Delegated Report

Planning Application No: 20240641
20240642

Location: Canal Basin Albion Parade Gravesend Kent

Description: 20240641 - Alterations to swing bridge.
20240642 - Application for Listed Building Consent for alterations to swing bridge.

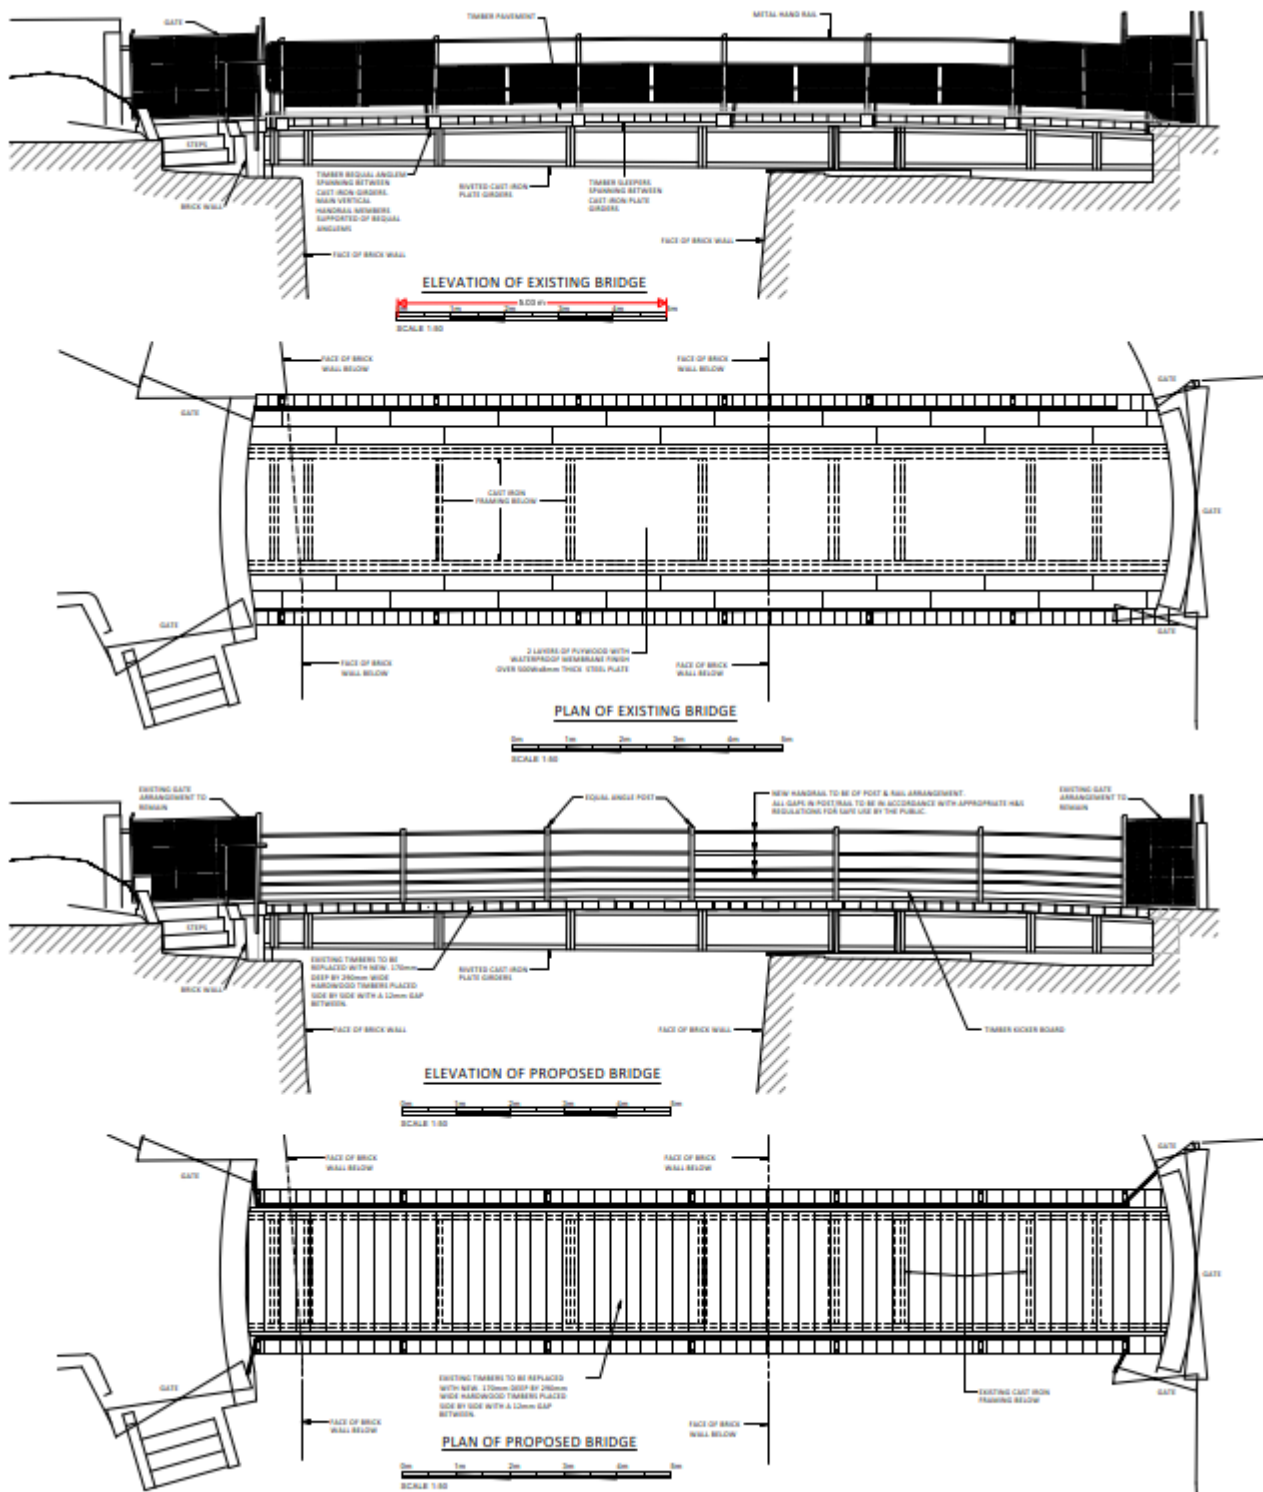
The proposal is therefore for a new design for the replacement timber structure on top of the main steel frame in order to lighten the weight of the bridge. It is proposed to do this by removing the side walkways; removing the hardwood decking overlay and spacing out of the sleepers below; and replacing the railings with new ones of a post and rail design.

The proposal to remove the two side walkways is considered acceptable as the walkways are not original but are a relatively more recent addition and their removal would revert the bridge back to its original width.

The replacement of the existing timber structure on top of the main steel frame is considered acceptable as many of the timbers are rotting and in need of repair, the timber structure is not original as it has been replaced more than once. It is proposed to use hardwood for the replacement timbers which is acceptable and sympathetic to the age and style of bridge. It would also be a hardy material to use given the environment the bridge is located. As originally submitted the timbers were proposed to be 170mm in depth x 290mm in width. The agent advised of a change in these measurements during the course of the application and the timbers are now proposed to be 150mm in depth x 230mm in width. The spacing

between the timbers would be the same as originally proposed – 12mm. The Conservation Officer advised the new measurement for the width was acceptable providing the thickness does not change. The thickness would change but would not be any thicker, it would be less, and the agent has confirmed that the timbers would sit within the grooves as such that there would be no visible difference in the thickness externally.

The replacement of the railings is considered acceptable as they are not original. The proposed post and rail design for railings is considered acceptable and is a light and open design sympathetic to the age and character of the bridge.

The Conservation Officer raises no objections to the proposal and requests conditions regarding a photographic record to include the land structure (kerbs, walls) either side of the bridge and scaled drawings at 1/10 and ½ of full size for the handrails, and intersection of the bridge with the granite kerbs, with final colour to be agreed and lastly details of the adjustments to the counterbalance system to ensure the weighted side of the bridge is balanced properly. The photographic record and scaled drawings conditions would need to be pre-commencement conditions and the agent has agreed to these.
